Duquesne Light

SUBJECT: Beaver Valley Power Station - Unit No. 2
Docket No. 50-412
FSAR Environmental and Hydrologic Engineering Branch Questions

Attached to this letter are Duquesne Light Company's (DLC) responses to the Environmental Hydrologic Engineering Branch (EHEB) questions (240.12-240.16) forwarded to DLC in you letter dated October 12, 1984, received October 18, 1984, and SER Open Item Nos. 1 and 2. These are also provided in response to the EHEB questions (240.1, 240.2, 240.4, 240.6, 240.7, and 240.8, dated August 13, 1983) in which the staff required revised information using Hydrometeorology Reports 51 and 52. It is DLC's understanding that responses to the above EHEB questions are now complete. These responses will be incorporated into the next FSAR amendment.

FIGURE 240.14-1

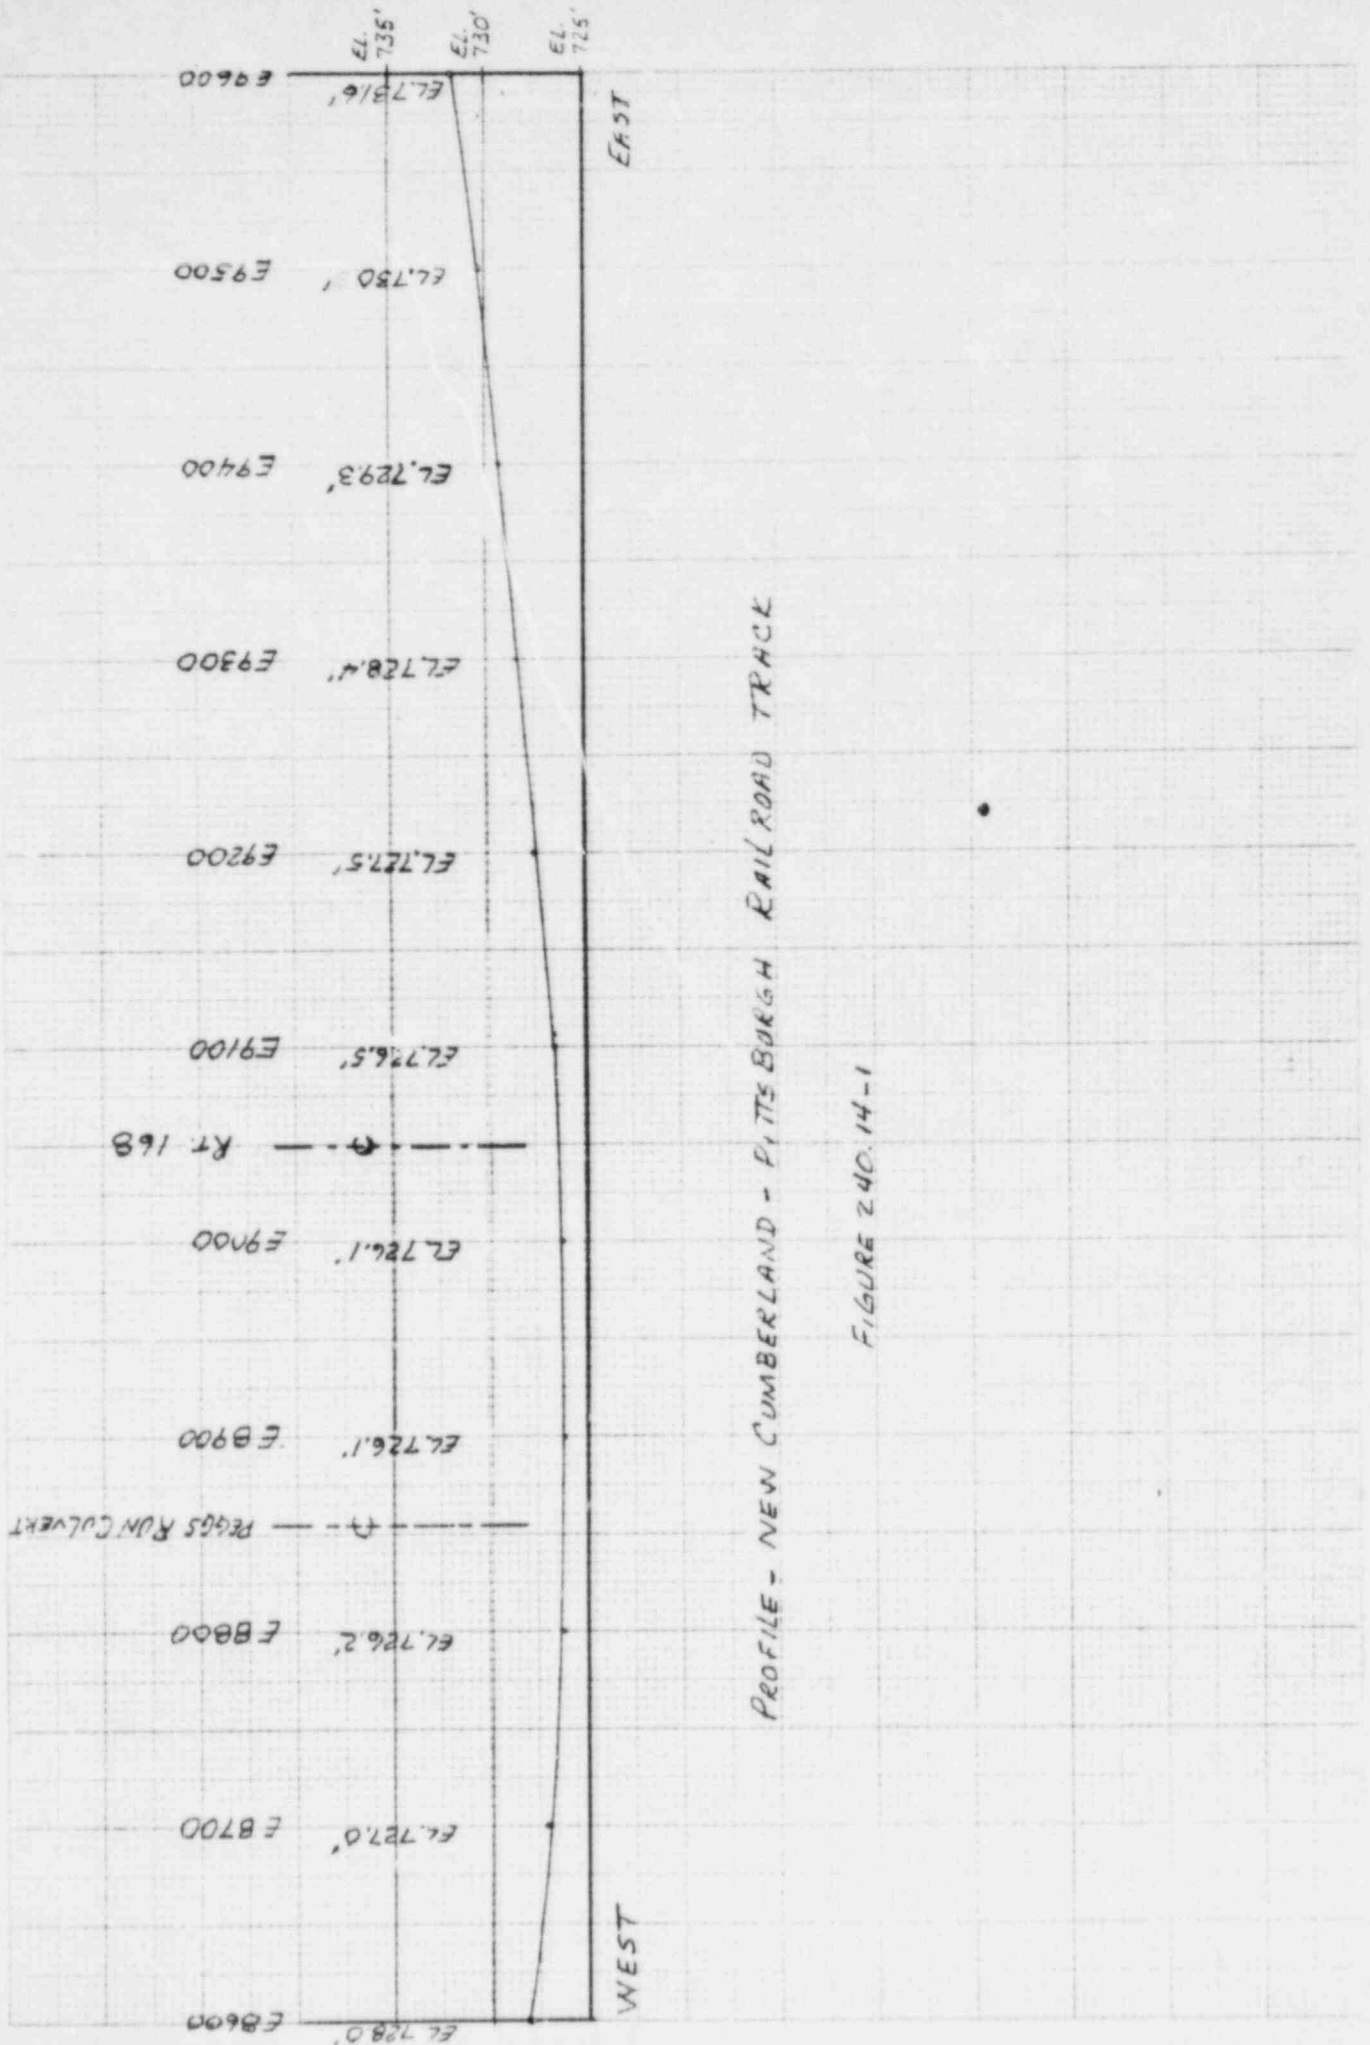
You have not provided any information concerning the effects of the RR culvert on potential flooding of the site. However, the staff notes that in responding to a USAEC staff position on the BVPS-2 PSAR, you stated that assuming the RR culvert is blocked and that the RR embankment does not wash out, water will rise to elevation of 729.6 ft on-site. In your analysis, you routed the Peggs Run PMF over the RR embankment assuming an 800 ft weir length. Is this analysis still valid? If it is, please provide the following information for staff review:

- a. The basis for assuming a weir length of 800 ft.
- b. A profile of the RR, in the vicinity of the culvert, showing elevations of the top of the rail at each break in slope.
- c. Elevation-storage data for the ponding area behind the RR embankment.

If conditions or design of the RR culvert have changed from the PSAR, you should reevaluate the flood potential of the RR culvert, make appropriate changes to the FSAR, and provide your reanalysis for staff review.

Over a 14,000 ft long section of Peggs Run is enclosed in a 15-ft diameter culvert (refer to Response to Question 240.05 for detail). The culvert is connected to the RR culvert and the stream channel is backfilled up to the ground level of approximately el 727 ft to 728 ft. The Peggs Run culvert was assumed blocked, and the PMF flow discharges through the channels east and west of Route 168. Hence, the RR culvert has no impact on the flooding of the site.

- a. The Peggs Run PMF discharges over the railroad embankment. The embankment is no longer a weir since the stream bed south of the railroad was backfilled up to the level of the embankment.
- b. A profile of the railroad in the vicinity of the culvert is shown on Figure 240.14-1.
- c. A site topographic map shows that there is no ponding area behind the railroad embankment.

FIGURE 240.15-2
CROSS-SECTIONS, WEST OF RT. 168

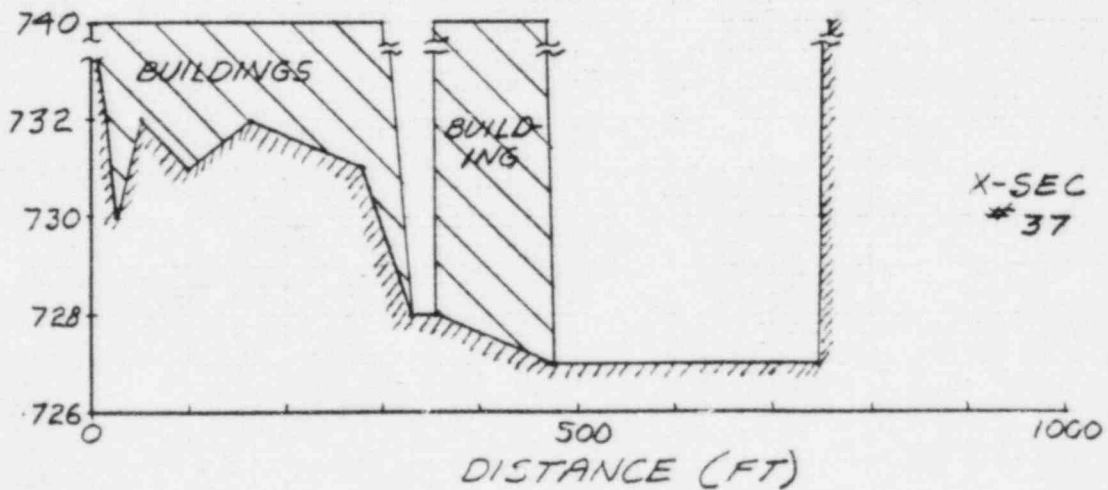
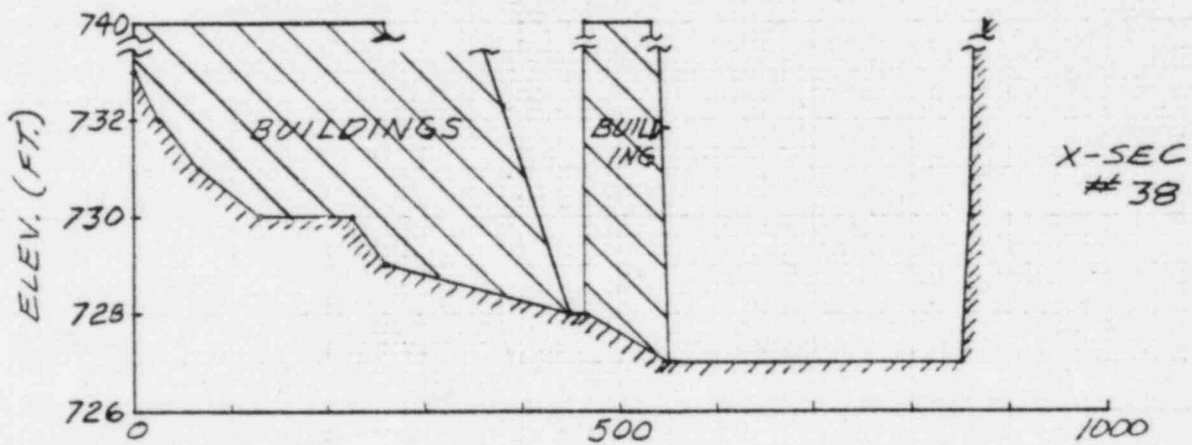
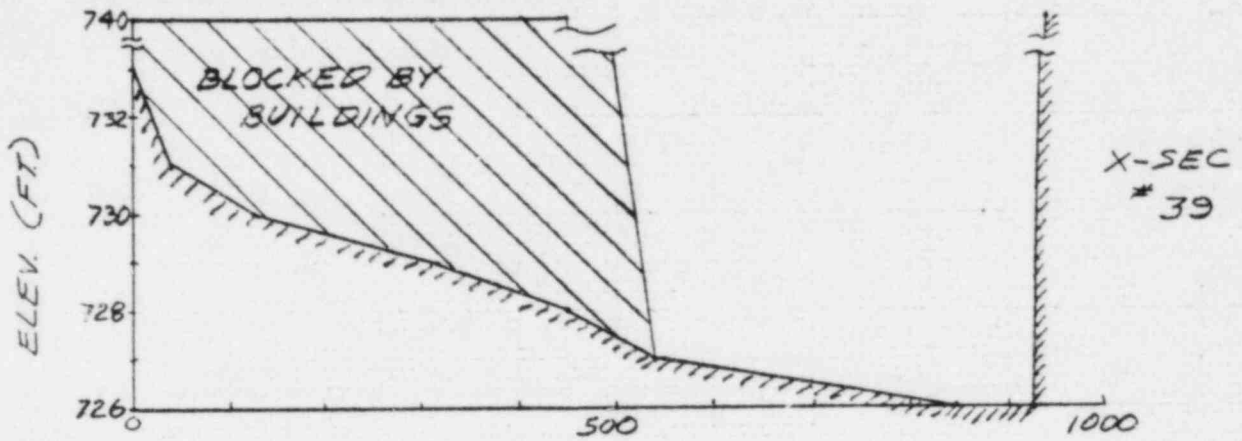
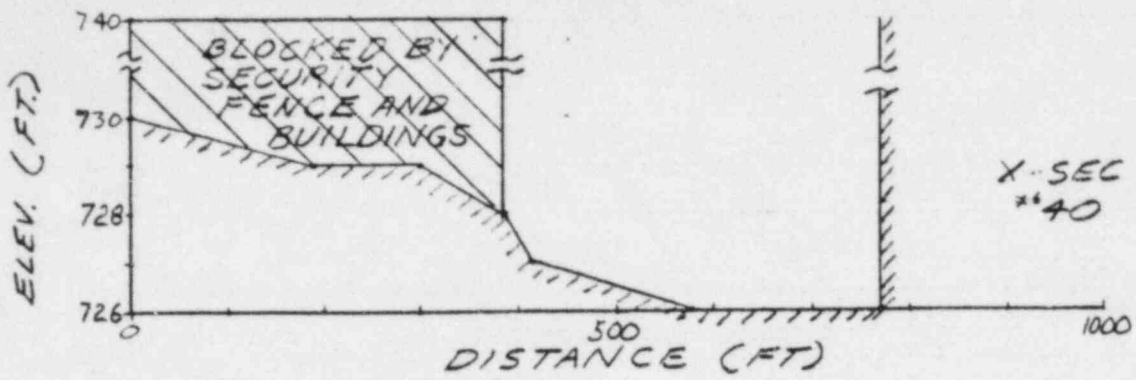
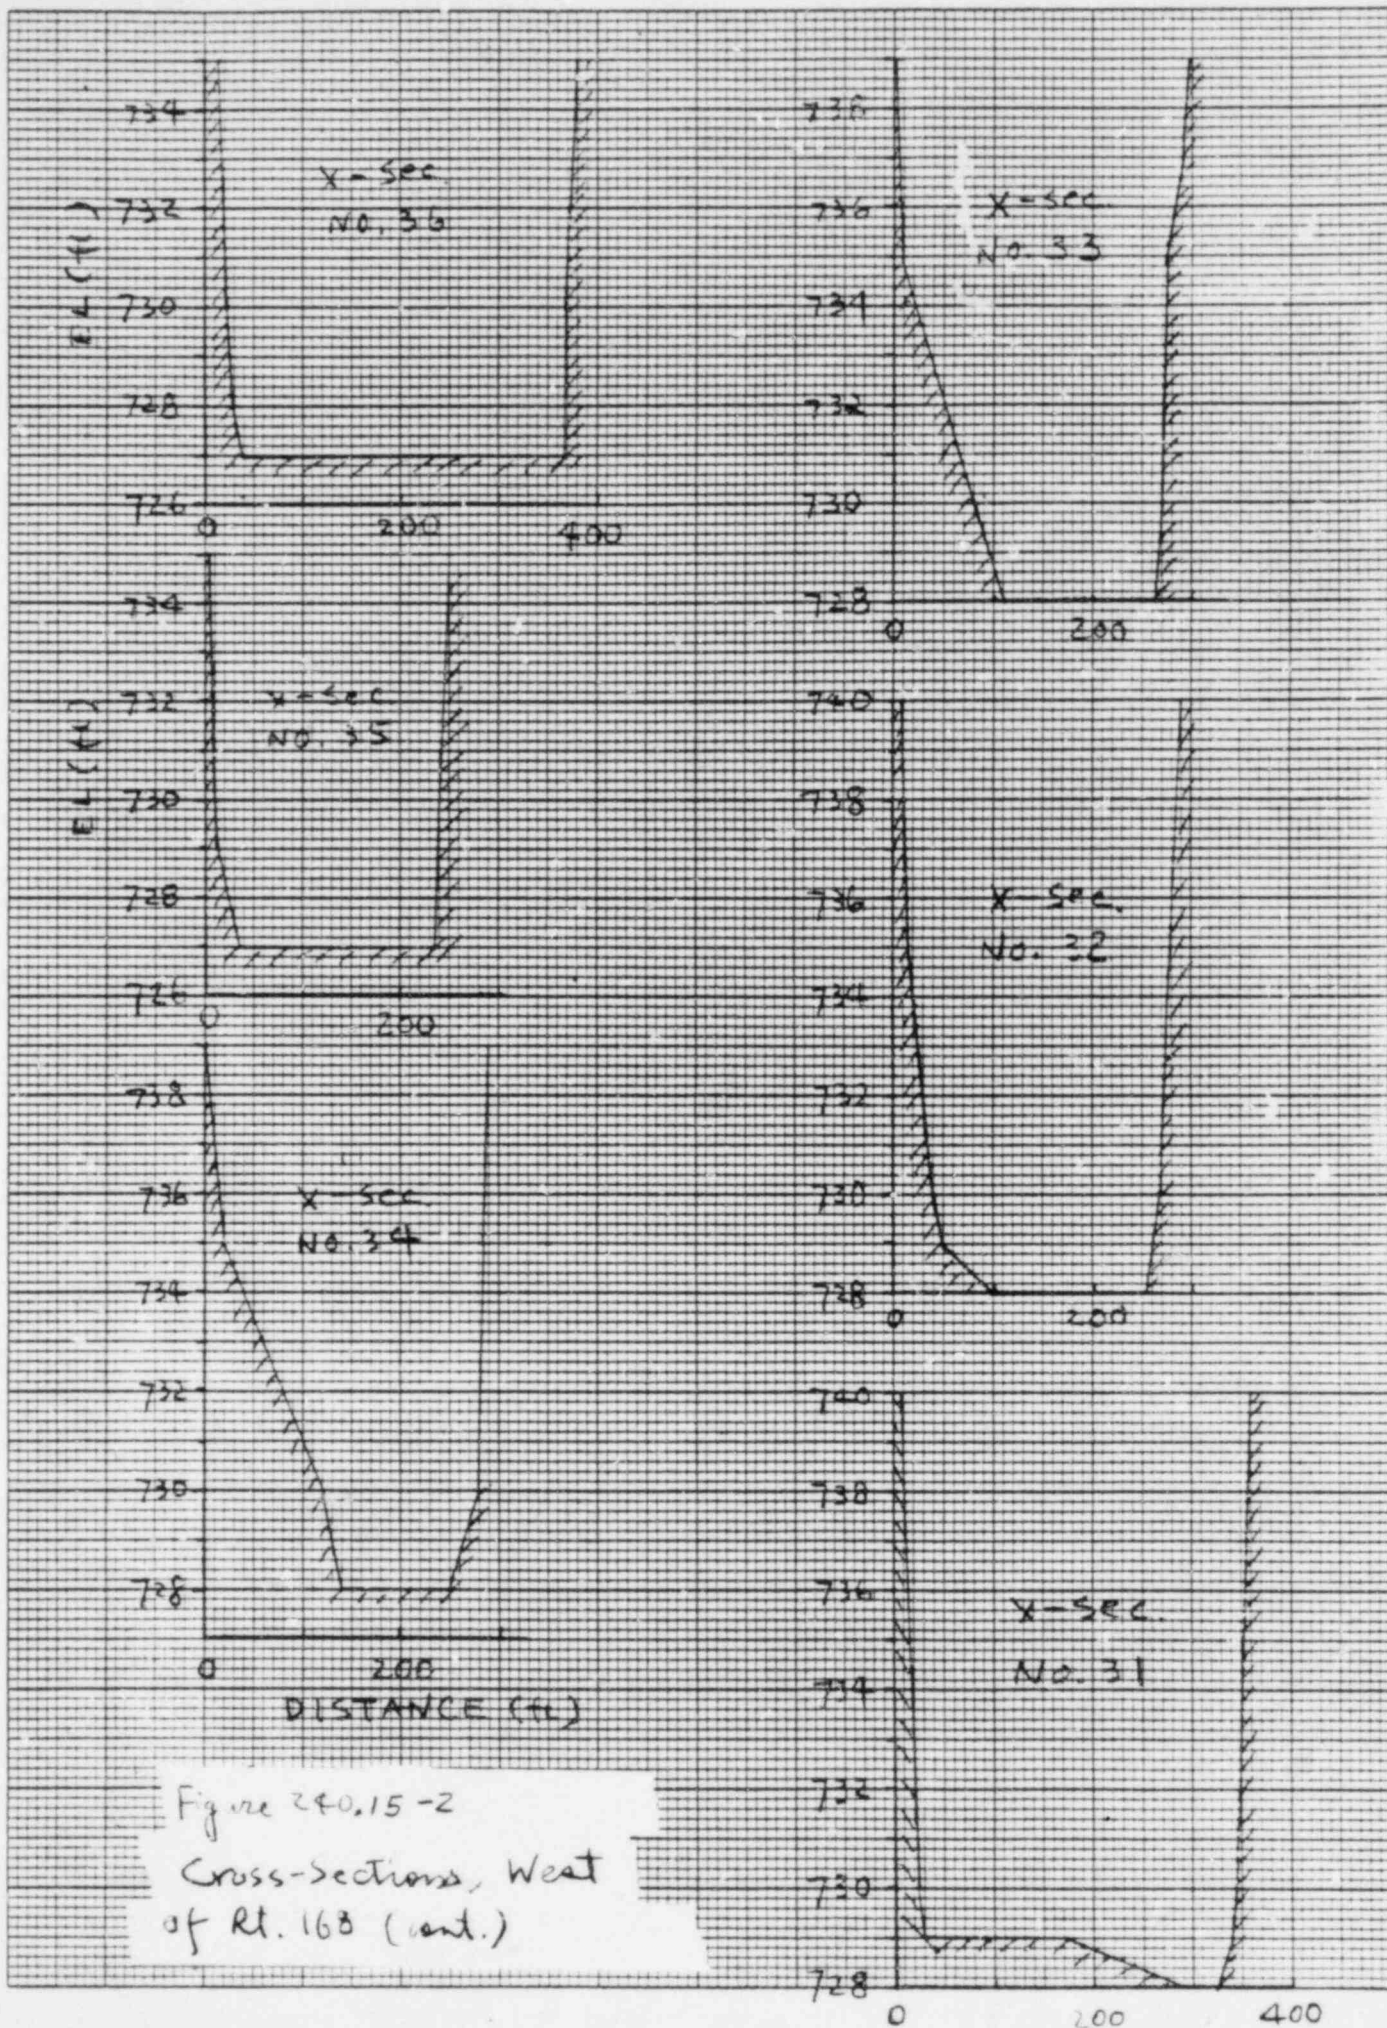
You state that you determined that, if the Peggs Run culvert failed during a PMF such that it would carry only negligible flow, due to blockage by debris, water levels in the vicinity of safety related structures would be below an elevation of 730 ft. What elevation did you calculate? You further state that the U.S. Army Corps of Engineers water surface profiles program HEC-2, was used to generate a series of water surface elevations. Please provide those elevations together with the cross-sections used and their locations. Also provide all pertinent values such as Mannings "n" values, flows, starting water levels, slopes, and any other assumptions used in computing water surface profiles. If you determined that water would overflow Peggs Run to the area east and south of the Highway 168 bridge approach, provide a detailed topographic map of this area.

The Peggs Run PMF peak flow of 17,000 cfs (Response to Question 240.13) was used for water level analysis. The flood flow is divided and discharges through channels on both sides of Route 168, near where Route 168 turns northwest before crossing the Ohio River. Most of the flow (15,000 cfs) discharges in the channel west of Route 168, following the general direction of the original Peggs Run, over the railroad embankment into the natural Peggs Run channel, and finally to the Ohio River. The critical section is at the northern edge of the railroad embankment where the ground drops down to the Peggs Run natural channel. A smaller portion of the flood flows through the channel east of Route 168. In the water elevation analysis, the security fences in the east channel were conservatively assumed blocked by debris. A critical depth occurred at the security fence section.

The division of the PMF flow by Route 168 near the turning point of Route 168 was evaluated for various flow rates using the U.S. Corps of Engineers' water surface profile HEC-2 program (1979). The calculation started from downstream control sections with critical depth and was carried upstream. By matching the water surface elevation from both channels at the point where the two channels join together with a combined discharge equal to 17,000 cfs, the flow rate for each channel was determined. Mannings 'n' values of 0.04 on the floodway channel and 0.05 on the overbank were used. The topography and cross-section locations are shown on Figure 240.15-1. Cross-section plots for the west and east channels are shown on Figures 240.15-2 and 240.15-3, respectively. HEC-2 input data for the west and east channels are presented in Tables 240.15-1 and 240.15-2, respectively. The water surface profile for the channel west of Route 168 is shown on Figure 240.15-4.
